NOTICE OF DECISION

DECISION OF THE HEARINGS OFFICER

CONDITIONAL USE / CLASS 3 SITE PLAN REVIEW CASE NO.: CU-SPR23-02

SUMMARY: New oil-change facility and residential units in the CR (Retail Commercial) zone.

1 DEVELOPMENT SITE PLAN
0' 5' 10' 20' 40' 60' 1" = 20'-0"

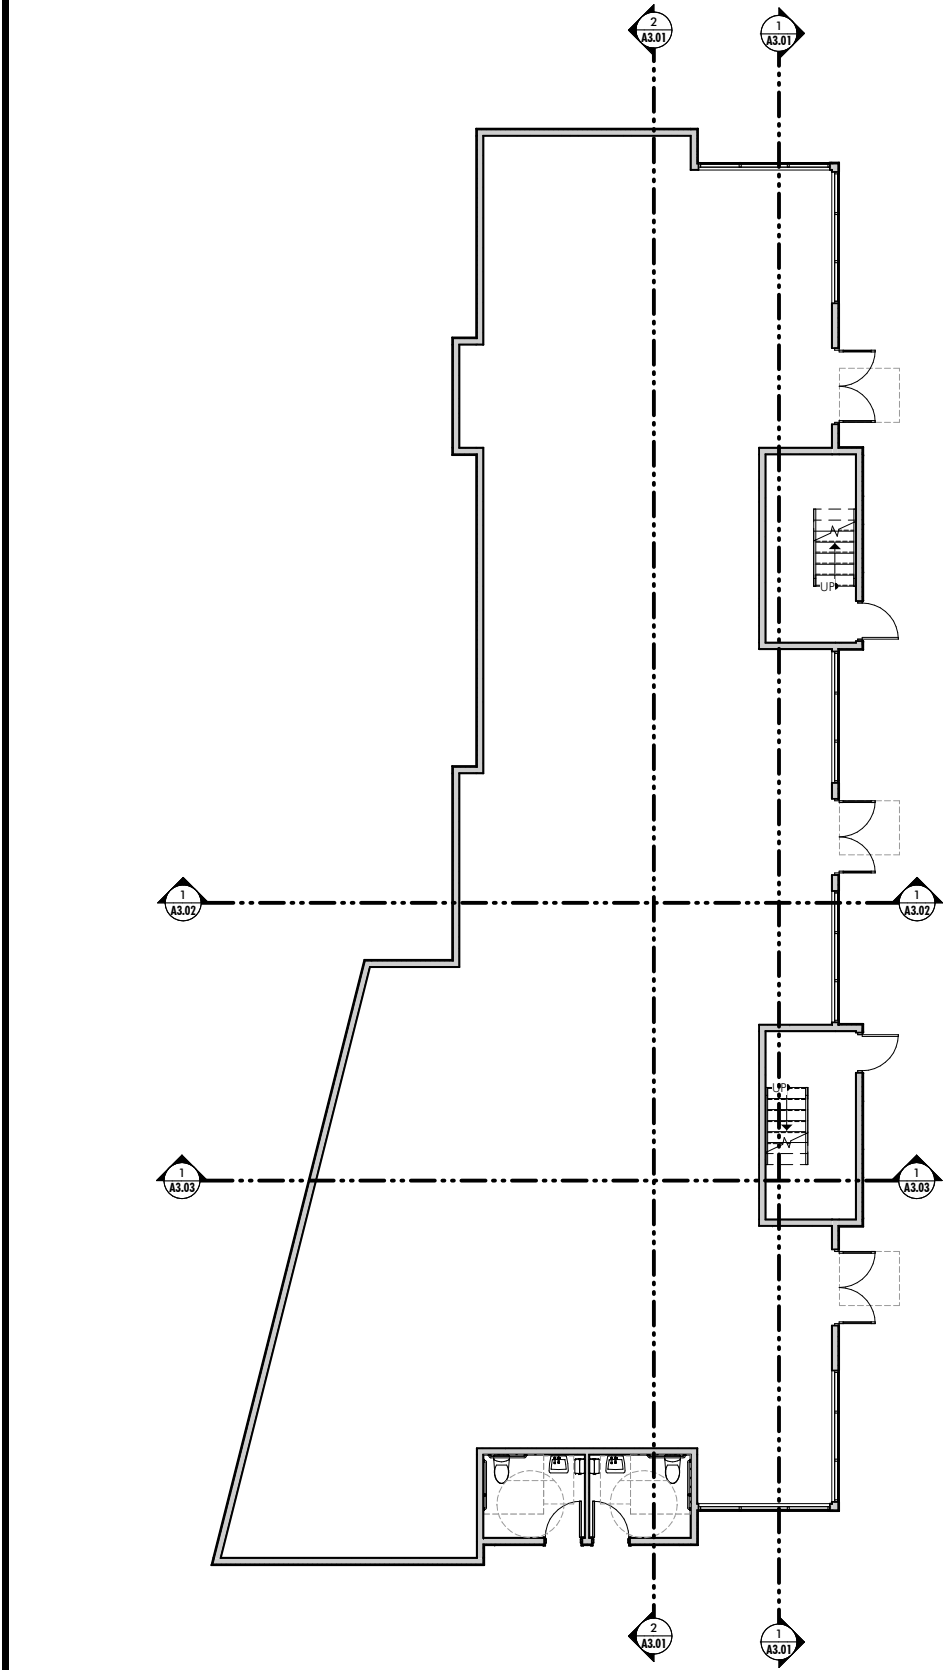
Finding: The proposed development does not change the location of any building or vehicle use area as approved under SPR-DAP22-46. The proposed oil-change building on the south parcel is set back at least five feet from the east property line and well over five feet from the south property line. The residential units proposed above the retail building do not extend beyond the approved footprint of the retail building except for proposed balconies on the west side of the building, which are still set back at least six feet from the closest point abutting the west property line. The proposal is in compliance with all applicable setback requirements of the CR zone and SRC Chapter 806.

The proposed site plan indicates that 48 parking spaces will be provided on site, 20 of which are compact spaces; therefore, the proposal meets the standards.

Finding: The applicant's site plan indicates four proposed bike parking spaces on the east side of the north building and four existing bike parking spaces on the east side of the south building, both of which are within a convenient distance of their respective building entrances. The applicant has provided details that indicate the bicycle racks meet the required dimensions and design standards. Further conformance will be verified at the time of building permit review.

There is an existing slope easement on the subject property that was acquired by the City of Salem for the realignment of Hagers Grove Road SE. The applicant's site plan shows one of the new buildings located within the easement area. New structures are not permitted within City of Salem easements. The Applicant's testimony at the hearing indicated that the proposed building plan eliminated the need for the City to require the existence of the slope easement, and that the City was in the process of removing the easement's existence. Prior to issuance of a building permit for the new structure, all, or a portion of, the easement must be quitclaimed to the property owner, or the easement must otherwise be altered or removed so that the proposed structure is not in a City easement.

- Condition 7:** All or a portion of the slope easement on the subject property that conflicts with the proposed building must be quitclaimed to the property owner, or the easement must otherwise be altered or removed so that the proposed structure is not in a City easement, prior to building permit issuance.
